# Agenda

## Planning Decisions Committee

6.30pm, Wednesday 14 July 2021

1. This report provides the Planning Decision Committee (PDC) with an assessment of planning permit application PLN20/0869 against the provisions of the Yarra Planning Scheme (the Scheme) and recommends that Council notify the Victorian Civil and Administrative Tribunal (VCAT) and all parties to the proceeding that Council supports the application, subject to conditions contained within the officer recommendation.

**Figure 14 – General extent of demolition proposed (exclusive of proposed demolition of roof, doors and windows to former bakehouse building).**

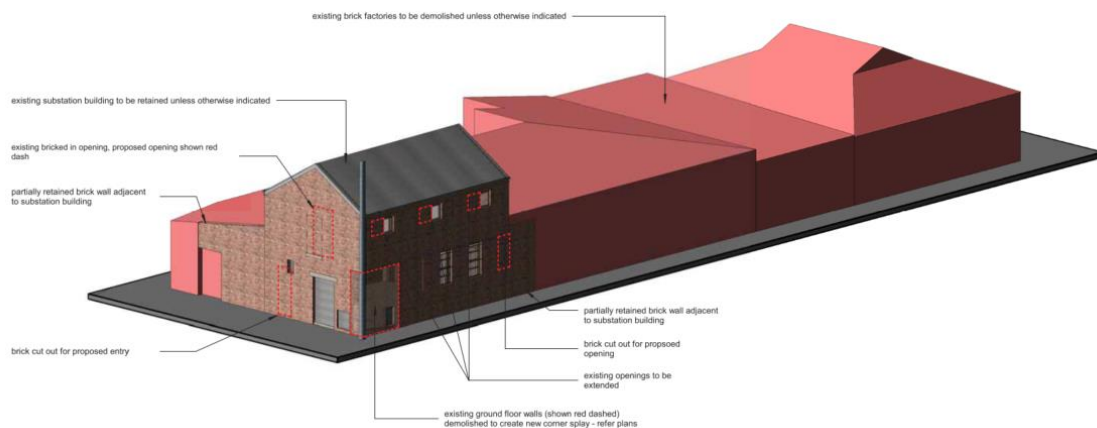
143. The extent of demolition of the site is depicted in figure 14, however, this perspective does not show all parts of the former bakehouse building to be removed (it does not show removal of roof sheeting, removal of part of the roof structure at the northern corner; and removal of all existing doors and windows which are necessary to be removed to accommodate proposed external alterations). Ground and first floor demolition plans and elevations clearly showing all demolition will need to be provided via condition on any permit that issues.

Figure 16 – Typical section showing elements projecting to maximum height

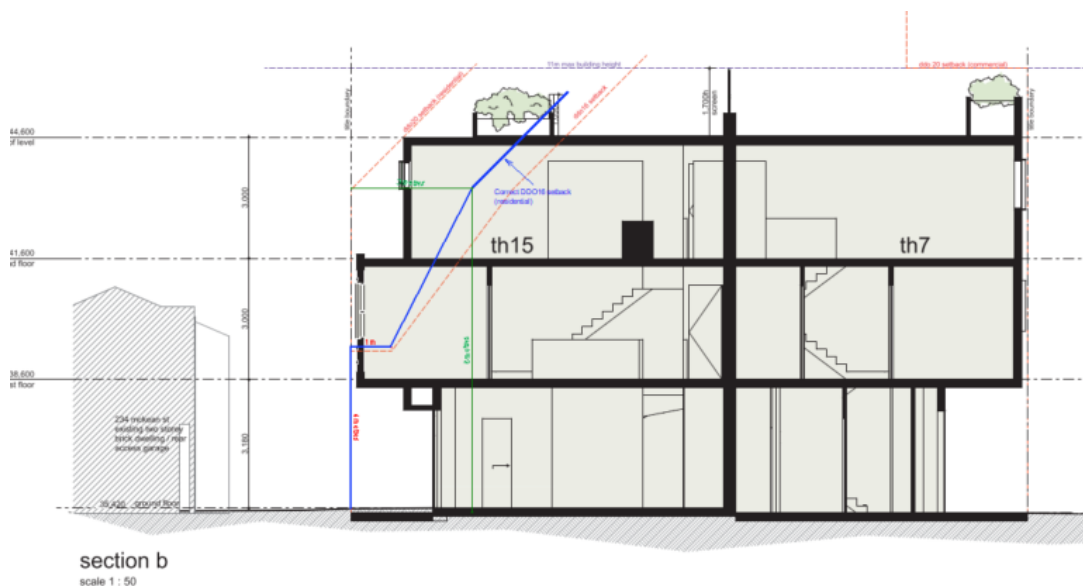
164. As per the table above, the 11m height of the building is well under with the maximum mandatory building height permissible under the current DDO20 (21.5m), which must be met for a permit to be granted. It also achieves the proposed 11m maximum mandatory height control of proposed DDO16, with most of the development under this height (see sectional diagram below for typical section showing height of building) with only privacy screening elements reaching this height.

169. However, although none of the dimensioned heights on the elevations (and sectional diagrams) show any parts of the building exceeding 11m, there are some portions of the privacy screens and some minor projections associated with the stair access to the roof terraces (see figure 17 below) that are not dimensioned or captured in the sectional diagrams. To ensure these elements do not exceed the purported maximum 11m height, a condition of any approval will require additional sectional diagrams demonstrating the all upper level privacy screens and stair structures associated with the proposed roof terraces are no higher than 11m above natural ground level.

**Figure 18 - land associated with No. 380 Queens Parade.**

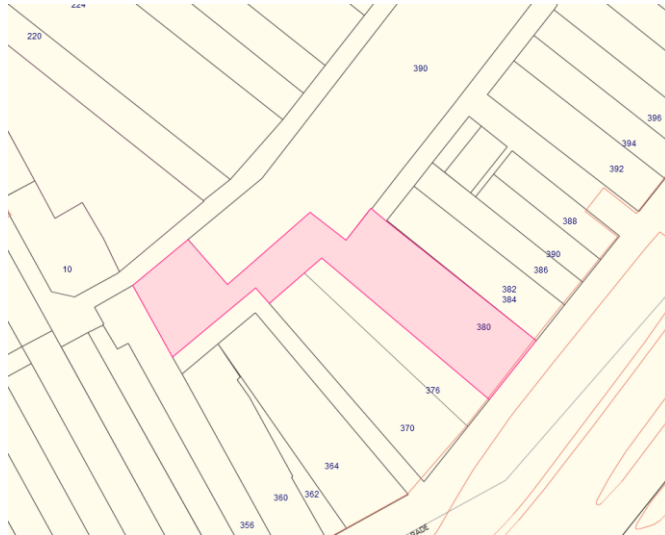
- (a) The adjoining property to the south-east against which the boundary wall extends up to 10.39m, is part of an irregular shaped parcel of land that is formally addressed as No. 380 Queens Parade – see Figure 18 below. Currently there is a single-storey industrial warehouse style building constructed to the shared boundary with the subject site and thus there would be little amenity impact from the proposed on-boundary construction.

Figure 22 – Proposed Level 2 under previous proposal PLN19/0155 with red stars to SPOS of 218, 220 224 and 230 McKean St (left to right).

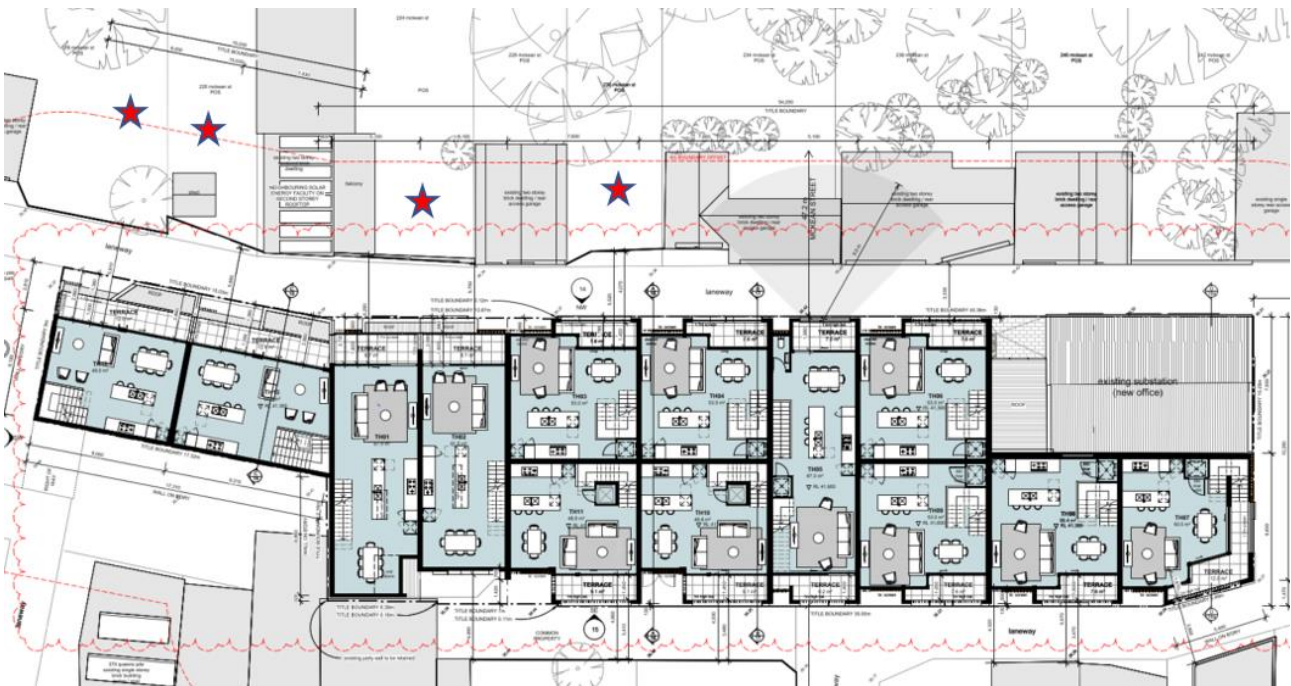
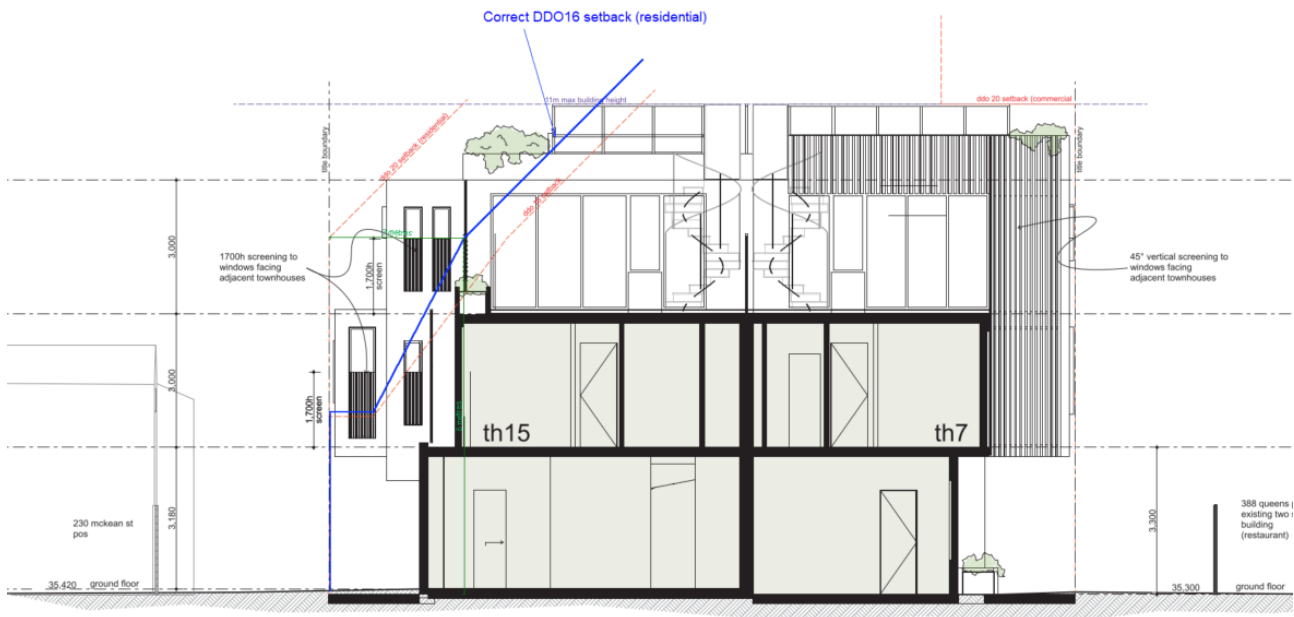
- (a) Lower overall height of the development (maximum of three storeys plus roof terrace instead of four storeys plus roof terrace) – see figures 20 and 21;
- (b) Lower prevailing height of the on-boundary built form to the north-west boundary (residential interface) at the northern end of the development (see figures 20 and 21 and also sightline diagrams within figure 29 later in the report); and
- (c) Significantly greater setbacks at upper levels where opposite unobstructed ground level rear secluded private open space of No. 230 & 240 McKean St (see figure 22 and 23 which compare level 2 setbacks).

196. The current proposal, in addition to reducing the proposed overall scale by one storey has provided additional recessed sections of the development opposite the secluded private open space of No. 230 and 224 McKean Street, in particular opposite the central portions of the open space opposite the following response is provided:

- (a) Opposite no. 230 McKean St - An open balcony at Level 2 extends between Townhouse 6, 7, 15 and 16 creating a substantial break in built form with only minor projections (lightweight screening and framing elements) projecting into the DDO16 setback profile – see figure 25.

**Figure 26 – Section through Townhouse 4 showing extent of compliance with DDO20 and proposed DDO16 setbacks to NRZ.**

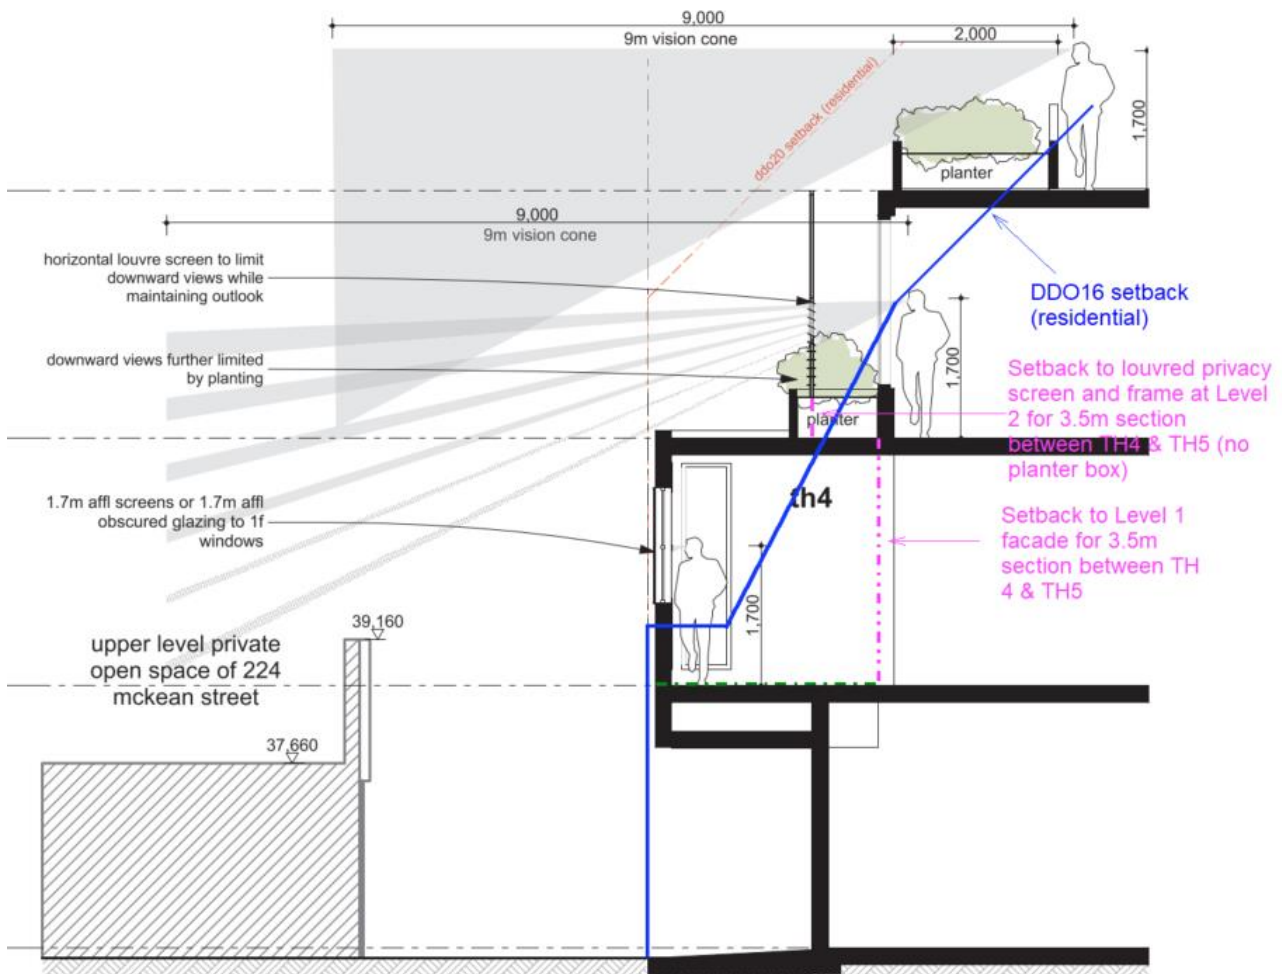
- (b) Opposite No. 224 McKean St – A 2.75m setback from the boundary to the main façade at Level 1 and Level 2 for a 3.5m wide section between TH4 & TH5, with only the lightweight framing element and privacy screening extending between the planter boxes projecting into the DDO16 profile – see figure 26 which is a section through an adjacent part of TH4 that has been annotated by the planning officer (pink lines) to represent the 3.5m wide section between TH4 and TH5 where there is an additional setback to the Level 1 façade and no planter box.

**Figure 27 – sectional diagrams showing indicative built form opposite No. 218 and 220 McKean Street for TH13 of previous proposal under PLN19/0155 (section C-C on left hand side) and TH2 current proposal (Section A-A on right hand side).**

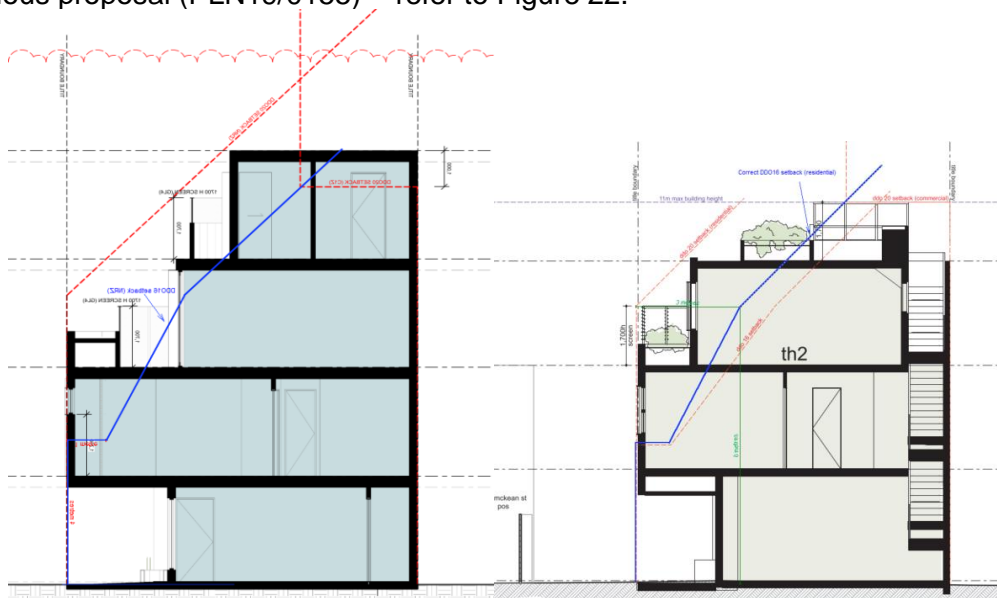
201. Figure 27 provides a comparison between proposed Townhouse 2 and the previously proposed Townhouse 13 under PLN19/0155 (the latter of which is representative of the same section of Townhouse 12 in that development). These sections are a “slice” through one relevant section of each dwelling and there is some variation to setbacks, particularly at first floor where a 0.98m setback was provided for much of the level 1 façade under the previous proposal (PLN19/0155) - refer to Figure 22.

**Figure 29 - Sightlines for current proposal (black dashed line is over (predominant) two storey built form and blue line is over single storey built form)**

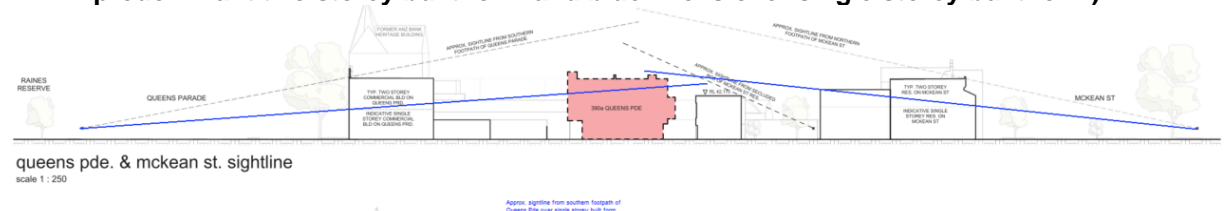
- (a) The development will be partly visible from the heritage streetscapes of McKean Street (between gaps in buildings) and Queens Parade (above single storey buildings and via laneways) – see figure 29. Otherwise the development will be concealed from surrounding streets and Council's Heritage Adviser has found that *the impact of the proposed new development on the broader heritage surrounds is very minimal*.

233. Figure 29 and the perspective in Figure 31 demonstrate that the proposed development is significantly lower in scale than the ANZ building which would protect any of the specified features. It is adequately separated from the ANZ building so as to not compete with it and where visible obliquely from the adjacent laneway will appear as a recessive element.

**Figure 30 – excerpt of diagram from Heritage Adviser referral showing location of original upper level window to north-west façade.**

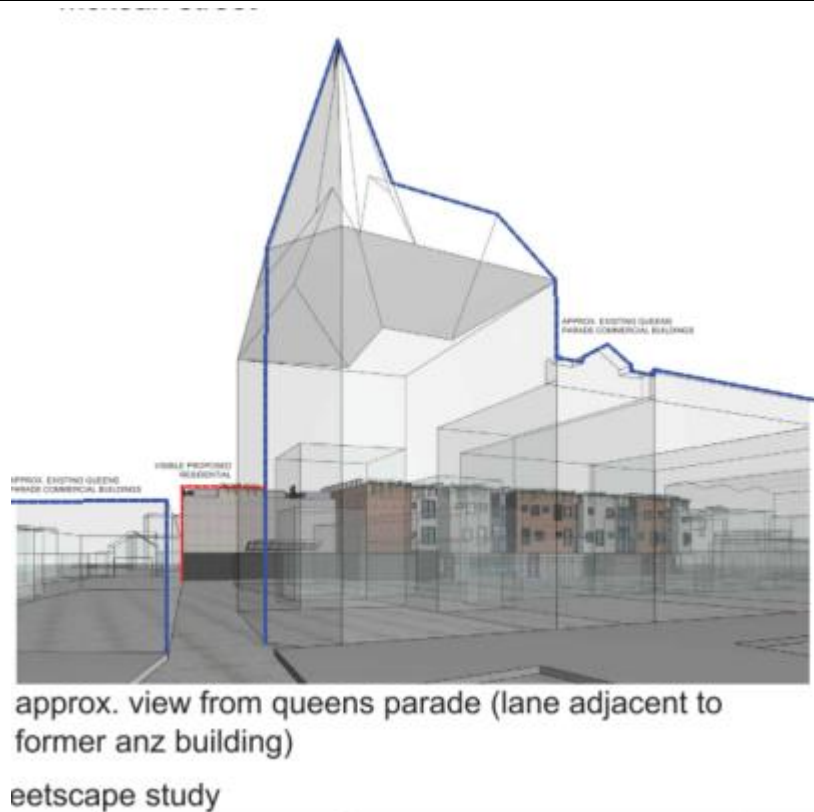
- (c) the new “off-centre” opening to the upper level of the north-east façade (the original opening as shown in figure 30 below must be re-instated with a traditional timber framed window).

**Figure 32 – New full height dwelling windows (yellow highlight) to north-west laneway under previous proposal PLN19/0155.**

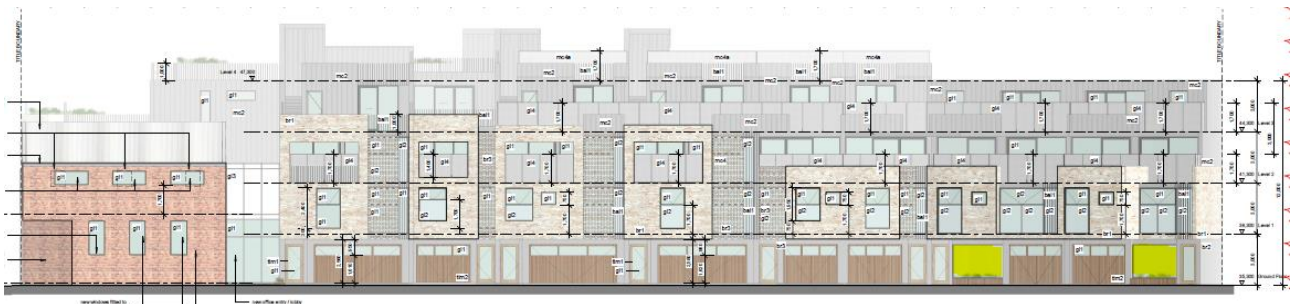
279. However, the extent of full length windows to dwellings at ground level to the public laneways is similar to the proposal under PLN19/0155, which was found to be acceptable. While there has been a reduction in the extent of habitable rooms at the southern end of the north-west laneway (only one smaller habitable room instead of two larger habitable rooms) full length windows have also been provided to the generous entry foyers to Townhouse 1 and 2. Furthermore, as these windows are not to sensitive areas it is also less likely that they will be covered up to protect privacy, thus maximising activation to the laneway.

287. Although Council's Urban Designer suggested that garages were overly dominant to the north-west facades, as per the comparison of elevations in figures 32 and 33 – this is not similar to the previous proposal under planning application PLN19/0155 and this was not raised as an area of concern in the decision by the Tribunal under P1950/2019.

**Figure 36– First floor habitable room windows associated with double-storey outbuildings at rear of dwellings fronting McKean St (highlighted in purple)**

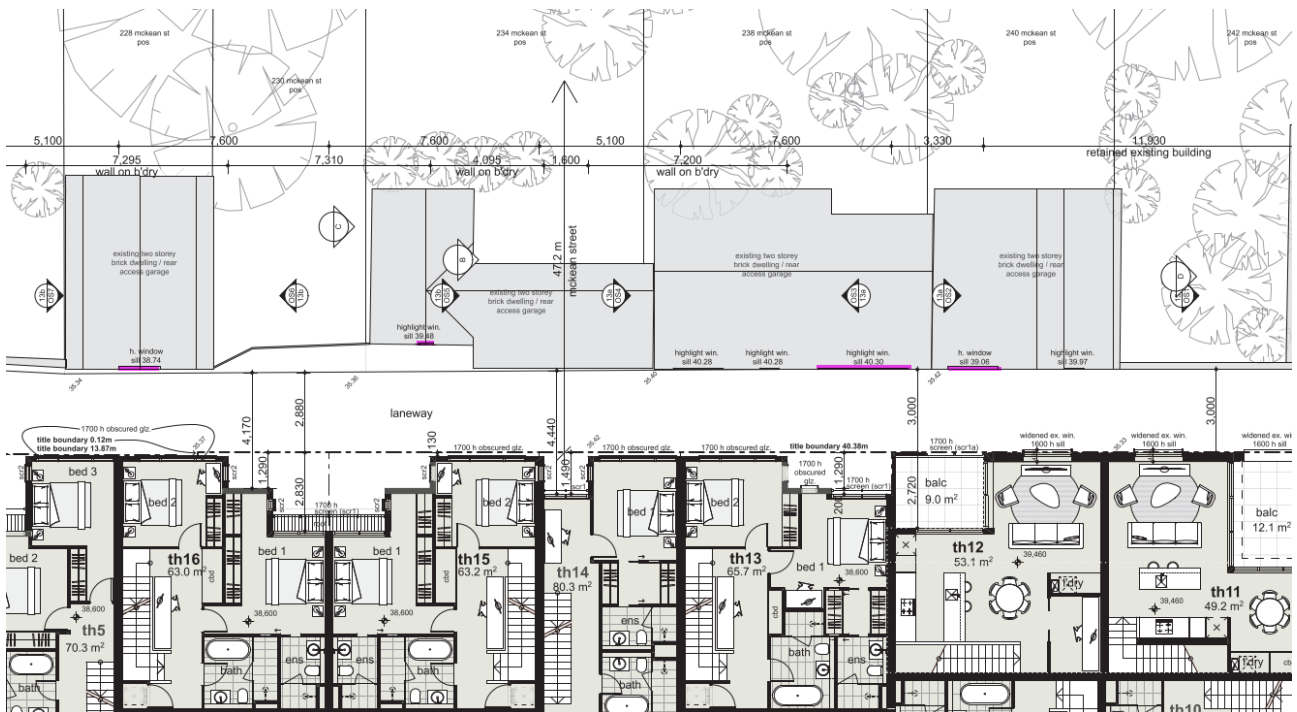
302. In relation to dwellings to the north-west of the site, a number of the residential properties have first floor habitable room windows facing the subject site (see figure 36 below).

**Figure 37 – modified overlooking section from Townhouse 11 showing impact of removal of window shroud.**

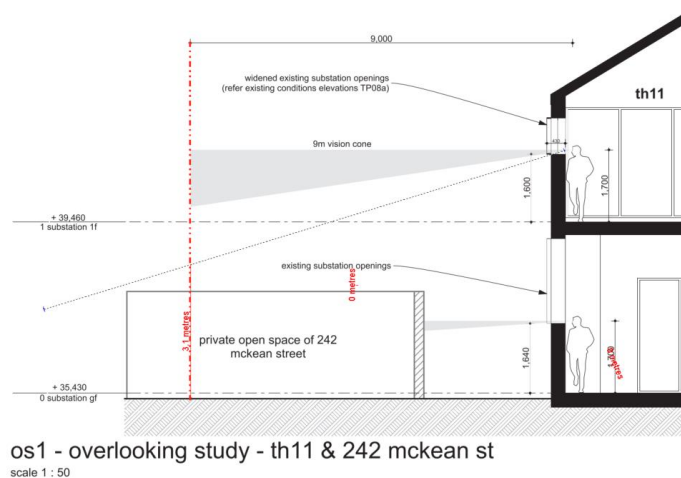
- The north-west facing habitable room windows to TH11 and TH12 and the north-west opening to the first floor balcony to TH11, have a sill height of 1.6m above finished floor level (below 1.7m prescribed by the Standard). Even without the modified extruded window frames (to be deleted as part of conditions relating to heritage impacts) the width of the existing wall would prevent views downward to secluded private open space opposite at No. 242 McKean St (as demonstrated by the modified overlooking diagram in figure 37). At the 9m mark the viewline would extend to a vertical distance of 3.1m from the ground which would not permit views to people in that space. As the conditions pertaining to heritage will also result in the original (smaller) windows or openings being kept in place, this would further limit opportunities for overlooking. However, consideration must also be given to the first floor north-east facing habitable room window associated with the rear outbuilding to No. 240 McKean St (see photograph in Figure 38). Extrapolating the information provided in the plans and sectional overlooking diagrams confirms that views into this window (with a sill height of RL39.06) would be possible from the north-west facing first floor window to Townhouse 12 (even with the proposed extruded frame/shroud). Hence, a condition will require that this window be screened in accordance with the standard. .

**Figure 39 – Screening device SCR3 detail**

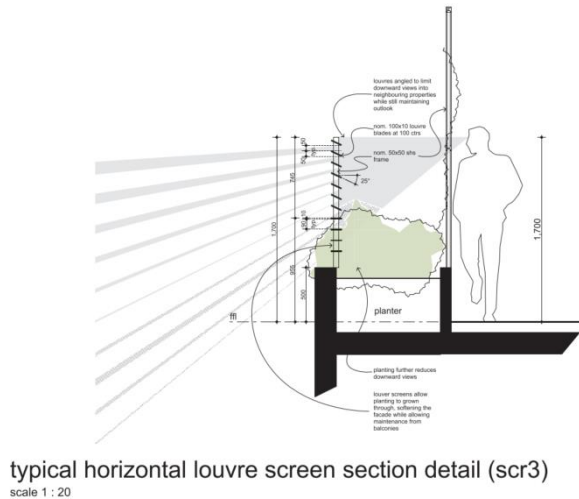
335. It also appears that the material and finish of screens Scr1, Scr2 and Scr3, while included in the legend (with detail provided on TP13D), have not been included within the materials and finishes schedule of TP14 and TP15. This will be required as a condition of any approval.

**Figure 40 - effect of screening SCR3 to overlooking beyond to dwellings fronting McKean Street.**

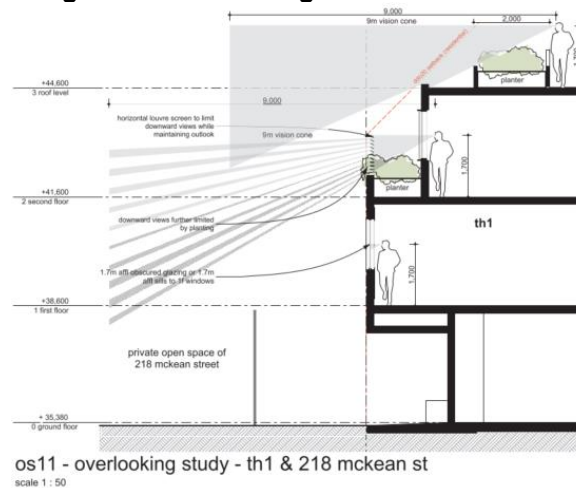
336. At level 3, the roof terraces are set back substantially from the rear of dwellings fronting McKean Street. The provision of 2m wide planter boxes, where within the 9m distance, ensures that downward views to any areas of secluded private open space or habitable room windows opposite is restricted. This is clearly illustrated in overlooking sections OS3-OS11 (drawings TP13a to TP13c of the decision plans) and Figure 40 above.
